APPLICATION NO.	FILING DATE	FIRST NAMED INVENTOR	ATTORNEY DOCKET NO.	CONFIRMATION NO.
10/024,223	12/21/2001	Sam Young Ahn	8733.523.00	3348
30827	7590	01/26/2006	EXAMINER	
MCKENNA LONG & ALDRIDGE LLP 1900 K STREET, NW WASHINGTON, DC 20006			RUDE, TIMOTHY L	
			ART UNIT	PAPER NUMBER
			2883

Office Action Summary	Application No. 10/024,223	Applicant(s) AHN, SAM YOUNG	
	Examiner Timothy L. Rude	Art Unit 2883

DETAILED ACTION

Fig. 1

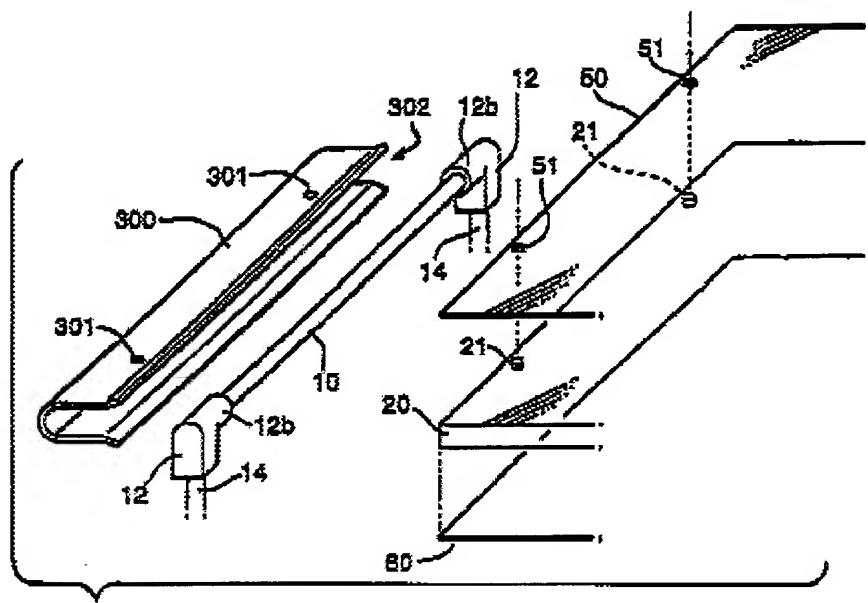
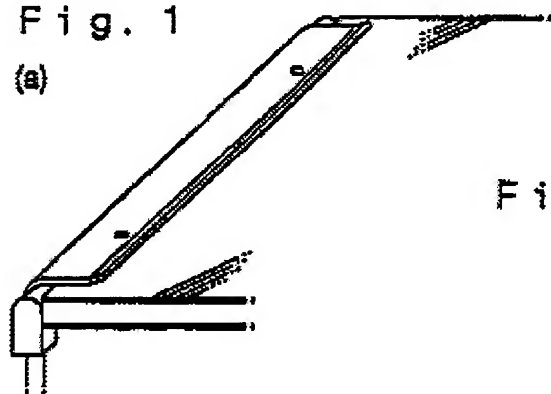
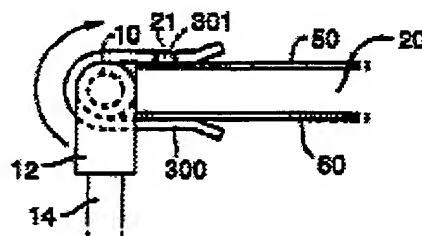
Furihata teaches 1) a backlight unit in Figure 1 comprising a clamping member, 300, disposed in said reflector, [60 and 300 comprise a two-piece reflector, col. 4, lines 20-32], and adjacent said main support for fixing them (col. 4, lines 62-67), and 2) a portion of an upper surface of said reflector, 60 and 300, is adjacent to a bottom surface of said light guide panel, 20, and wherein a portion of said upper surface of said reflector, 300, is non-adjacent to said bottom surface of said light guide panel, to provide proper assembly without an adhesive (col. 4, lines 59-61).

As to claim 2, Furihata, as combined above, teaches said clamping member includes: a protrusion projected with a fixed height from said main support and a hole,

51 (obvious to use on reflecting plate, col. 4, lines 62-67) which is formed in the reflector and through which said protrusion, 21, of said main support penetrates.

Furihata teaches the protrusions that are not greater than the sum of a thickness of the items that the protrusion penetrates [as illustrated in figures 1(a) and 1(c)] and holes may be used to secure the reflector and possibly other devices (col. 4, line 51, through col. 5, line 67).
